AMENDMENT NO. 2 OCTOBER 2024
TO
IS 17790 : 2022 INSULATED FLASK FOR DOMESTIC USE — SPECIFICATION

Amendment No. 2 to IS 17790 : 2022

FIG. 6 INSULATED FLASK WITH SPOUT/SIPPER/STRAW TYPE’

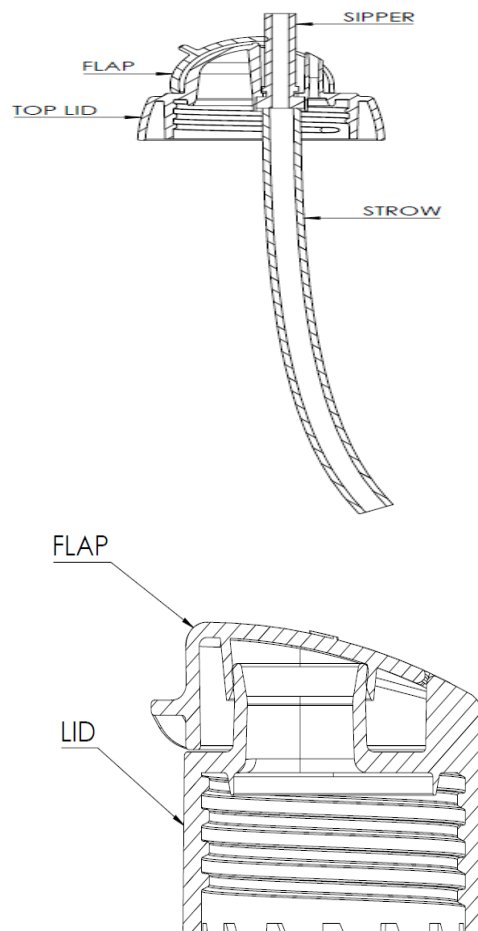
‘NOTE — If the stopper construction is as per Fig. 6 (with spout/sipper/straw type), the leakage test shall be conducted with water at room temperature. In case, a separate insulated lid is provided, the flask shall be tested as per 7.9 with the insulated lid also.’

(Page 7, Fig. 5) — Insert the following at the end:
